American Hakko Products, Inc.

PRODUCT BULLETIN

Bulletin No: PB381

Change to N51-01, N51-05, N51-06

N51-01, N51-05, N51-06

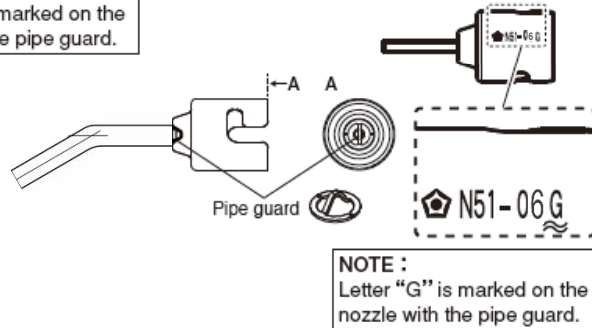
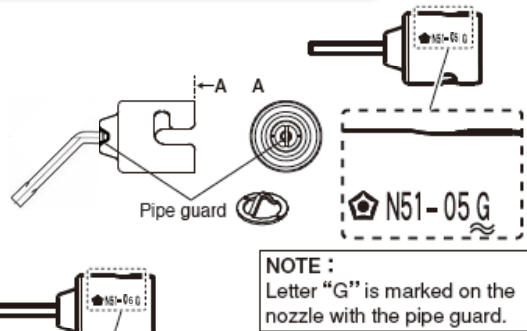
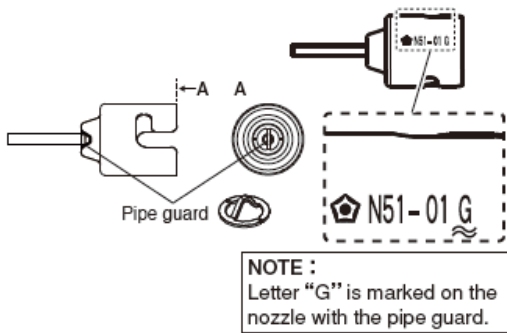
The N51-01, N51-05 and N51-06 nozzles have changed with an upgraded pipe guard that will prevent the use of the vacuum pickup and will prevent damage to the unit. The new nozzles will be denoted on the outside of the nozzle by a "G" following the part number.

Note: If using an older N51-01, N51-05 or N51-06 without a "G" denoted on the outside of the nozzle, do not use the vacuum pickup feature as you can cause damage to your unit. Please refer to PB378 FR-810B Hot Air Rework Station and the FR-810B User Manual, Section 4 for more information.
